Replace existing siding with new lap siding. Proposed windows on northwest side of the house to be sound proof -#1009 Grinnell Street-Seatech of the Florida Keys (H12-01-721)

This staff report is for the review of a Certificate of Appropriateness for a request for removal of 90 % of existing siding and its replacement with new lap siding. The house exhibits novelty, board and batten and lap siding in the exterior walls. According to the applicant there are two factors for this request, decay of some siding and to have a uniform siding material on the exterior. The proposal also includes the introduction of sound proof windows on the north side of the house. After the Agenda was published the applicant clarified to staff that the sound proofing for the windows will be done in the interior.

# PROPOSED NORTHWEST ELEVATION

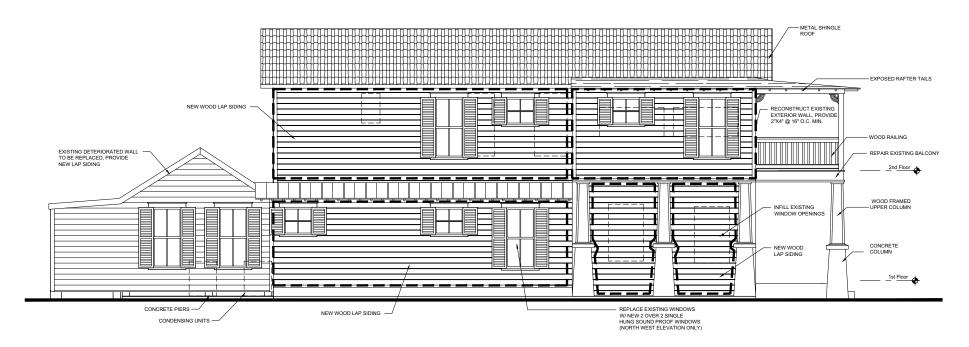
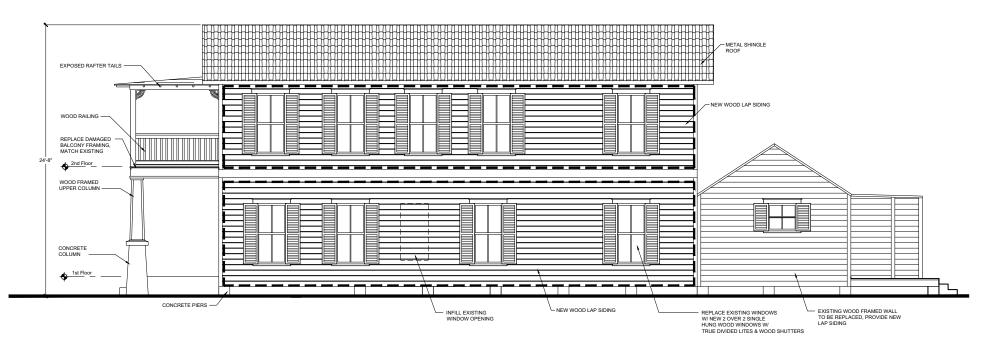
It is staff's opinion that the proposed plans are inconsistent with the guidelines. It is fairly common to find board and batten siding on the sides of a building while lap or novelty siding is observed on the main façade. Staff understands that the there is a percentage of siding that can be save and should be preserved. For the historic portion of the house what needs to be replaced must match the existing in form, material and dimensions.

The proposed 2 over 2 single hung soundproof windows....I need specs (are they wood? true divided? size of muntings?) I need percentage of siding to be replaced...will it be 100%?

And the 90% of the siding will be replaced because????

I have researched the sound proof window issue. The windows will remain 2 over 2 single hung wood windows with true divided lites. The sound proof part is actually a separate system that the client will install on the <u>interior</u> of the window opening. It is not visible from the outside of the building.

As for siding being replaced... I ran the calculations and 90% of the siding will be replaced. The other 10% is existing novelty siding that will be repaired.

The existing siding is damaged & deteriorated...a large majority of it has holes in it that you can see through.

Plus we feel it may be more attractive to have one or two types of siding (lap and novelty) rather than having an assortment of different types of siding all over the house which is the condition it currently is in. As you can see on the elevations and in the pictures the existing home has portions of lap siding, novelty siding, board and batton siding, and a sort of bead board siding.
